Access Compliance Report

Public Rights-of-Way

Intersection ID: 50239	Main Street: EVERGREEN TERRACE DR	Cross Street: LONGSTONE LN	Location: SW
ADA ID: 2194BE1865E3	Ramp Type: Perp	Initial Pass/Fail: Fail	Overall Compliance: No
		Severity Score: 12.5

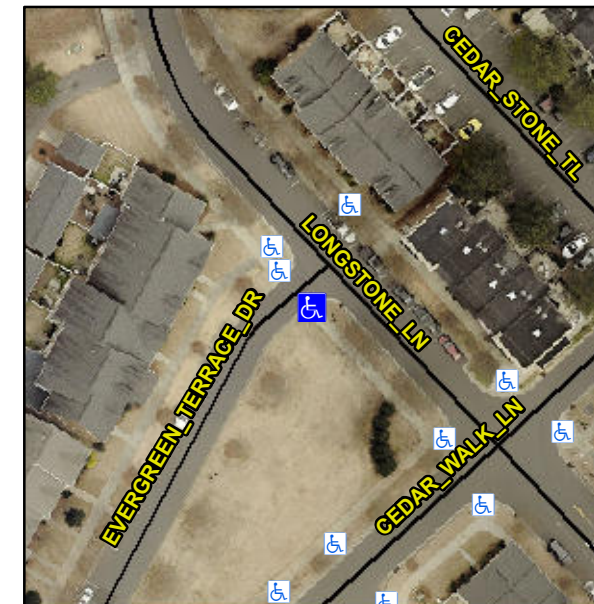
R304.2.2

Compliance	Description	Data	Compliance	Description	Data
N/A	Ramp Length (in)	59.0	No	Ramp Slope (%)	9.3
Yes	Ramp Width (in)	48.0	Yes	Ramp XSlope (%)	0.4
N/A	Flare Type LT	N/A	N/A	Flare Type RT	N/A
N/A	Flare Slope LT (%)	N/A	N/A	Flare Slope RT (%)	N/A
N/A	Flare Traversable LT?	N/A	N/A	Flare Traversable RT?	N/A
N/A	Landing Length (in)	N/A	N/A	DWS Provided?	N/A
N/A	Landing Width (in)	N/A	N/A	DWS Contrast?	N/A
N/A	Landing Slope (%)	N/A	N/A	DWS Length (in)	N/A
N/A	Landing X Slope (%)	N/A	N/A	DWS Full Width?	N/A
N/A	Landing Curb? (Y/N)	N/A	N/A	DWS Offset (in)	N/A
N/A	Shared Landing?	N/A			
N/A	Gutter Ponding?	N/A	N/A	Gutter Slope (%)	N/A
N/A	Gutter Lip Ht (in)	N/A	N/A	Gutter X Slope (%)	N/A
N/A	Painted X Walk1?	No	N/A	Painted X Walk2?	N/A
	X Walk 1 Direction	To NW		X Walk 2 Direction	N/A
N/A	X Walk 1 Width (in)	N/A	N/A	X Walk 2 Width (in)	N/A
	X Walk 1 Slope (%)	0.0		X Walk 2 Slope (%)	N/A
	X Walk 1 X Slope (%)	1.4		X Walk 2 X Slope (%)	N/A

Remove & Replace Entire Ramp.
